**SUPPLEMENTAL INFORMATION #1**

**Re: Rolling Meadow Ranch, LLC, Conditional Use Permits**

Record Number: PLN-12529-CUP

Re: Comments Concerning Revised Initial Study / Mitigated Negative Declaration for the Rolling Meadow Ranch, dated November 25, 2020; Six Conditional Use Permits for Commercial Cannabis Facilities (PLN-12529-CUP; SCH#2020070339)

**Road Point 4:**

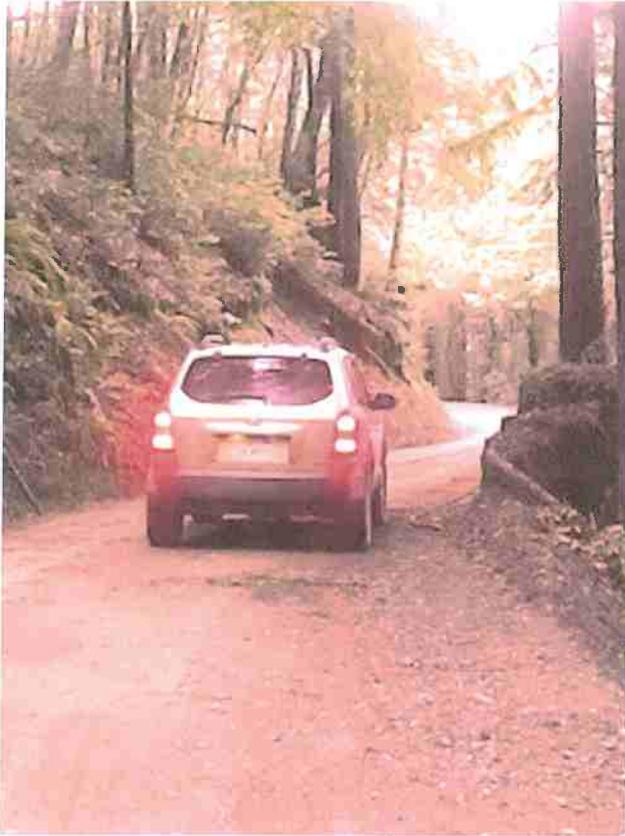
“Road Point 4” in the Access Assessment is particularly worrisome to me, because it is on the part of the Humboldt County road that bisects my property. The former owners, Art and Barbara Perra, experienced a landslide in the mid-1990’s caused by logging on the parcel above. This slide blocked the county road at this point, destroyed some of the structures on the property, and is still evident all the way down to the river. Humboldt County repaired the road, installing a culvert of questionable engineering, making this area prone to the same sort of catastrophic slip out as the one that occurred in 2017, up the road, for the same reasons.

**ROADWAY CATEGORY 4 (TWO LANE- NARROW TRAVELED WAY)**

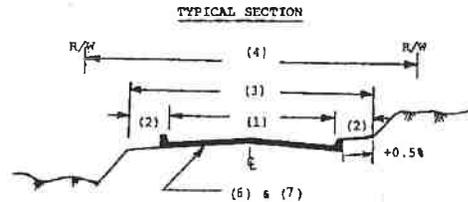
Specifically, I was asked to determine if the road meets the design standards of a Category 4 (or equivalent) road. The pertinent design standards are presented on Figure 7-302D (below).

Figure 1. A one-mile radius around the 2003 nest site. Project areas are shown in red and two locations are within the one-mile no disturbance buffer. Note: alternative nest sites may be closer to the Project.

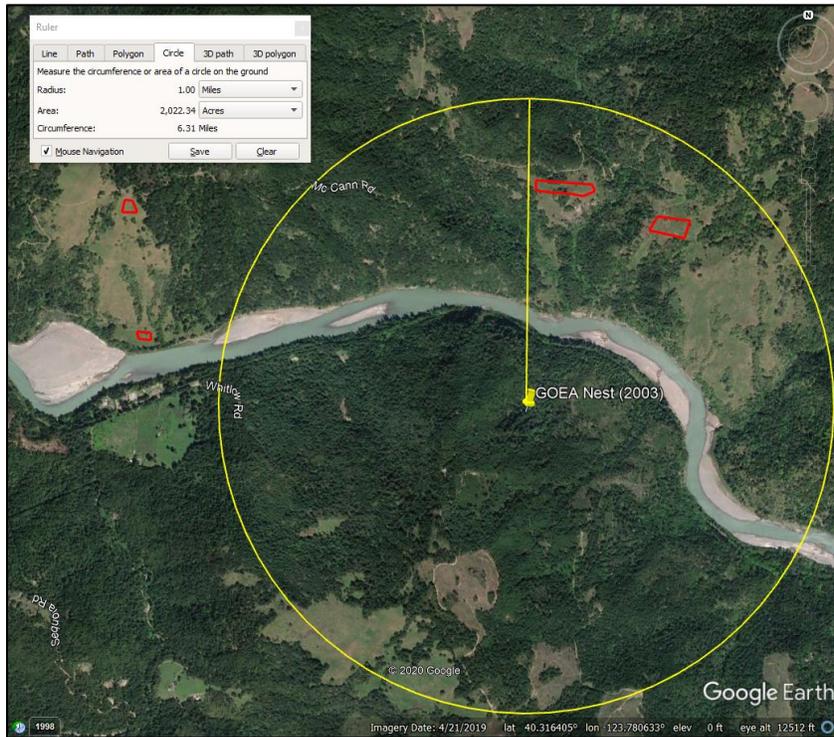
they are feeding nestlings (USFWS 2020). From the location of the documented 2003 nest site, the Project's two eastern most clusters of greenhouse facilities lie within one-mile and are within in line-of-site of the nest location (Figure 1- 2). The juxtaposition of the Project area to the 2003 nest site would maximize visual and other disturbances perceived at the nest site and potentially eliminate the majority of the foraging habitat within the core area (Figure 1 – 2).

Figure 2. A documented golden eagle nest site (yellow pin) is within line-of-site of Project cultivations areas (shown in red). Note: alternative nest sites may be closer to the Project.

Figure 3. Assuming no golden eagles forage within 1,000 meters of cultivation sites, the Project would result in a 57 percent reduction of foraging habitat within a one-mile no disturbance buffer.

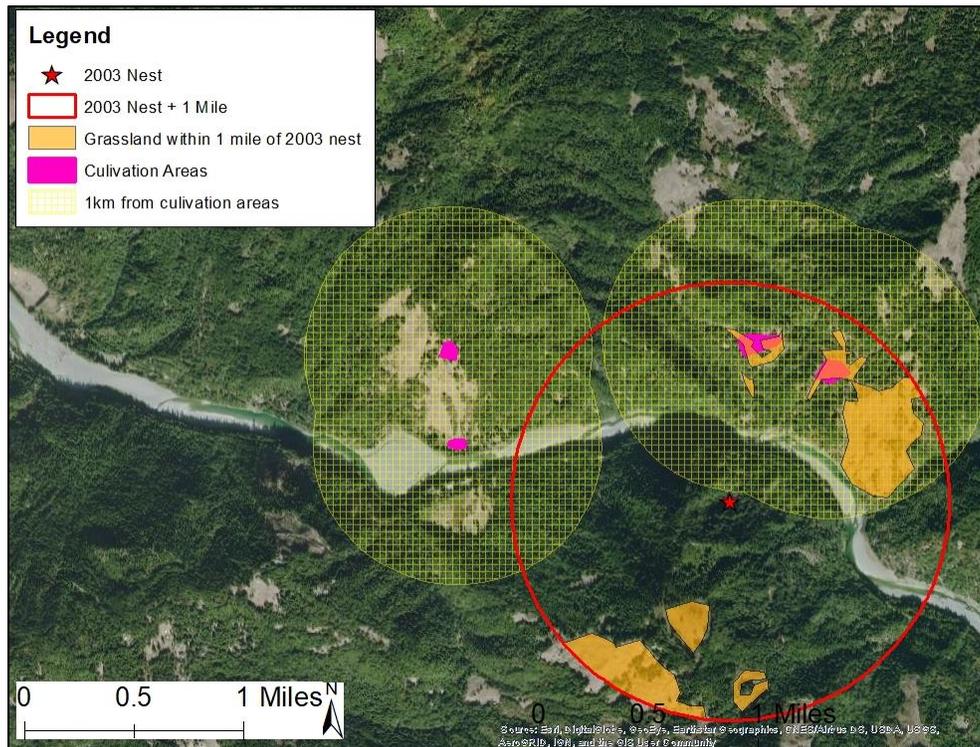
**Golden Eagle Sensitivity to Disturbance.** Although not well described in the Environmental Setting section of the IS/MND, the pre-Project baseline level of anthropogenic disturbance (e.g., visual, noise, and light) is very low or non-existent within the Project area. Any golden eagles in this vicinity are likely to be especially sensitive to human disturbance. Based on the range of disturbance distance thresholds for golden eagles (Hansen et al. 2017), they may flush from their nests or reduce feeding young with even low to moderate disturbance (including pedestrian activity) occurs within 1,000 meters (3,281 feet or 0.62 miles). Furthermore, nest-site protection is only beneficial if there is adequate access to prey. While male golden eagle's presence at nests is generally limited to prey delivery or brief assistance with young, they frequently rest on perches in view of nests (Watson et al. 2014). In southwestern Idaho, golden eagles perched away from nests were 12 times more likely to flush in response to recreationists than eagles at nests (Hansen et al. 2017). This suggests frequent human activity away from nests could result in chronic disturbance of foraging golden eagles and reduced provisioning rates at the nest. For example, if the 1,000-meter disturbance metric is applied to Project cultivation areas that may affect grassland foraging areas within a one-mile no disturbance buffer of the 2003 nest site, approximately 125 acres of 219 acres (57 percent) of foraging area may be avoided by foraging golden eagles attempting to feed their young (Figure 3).
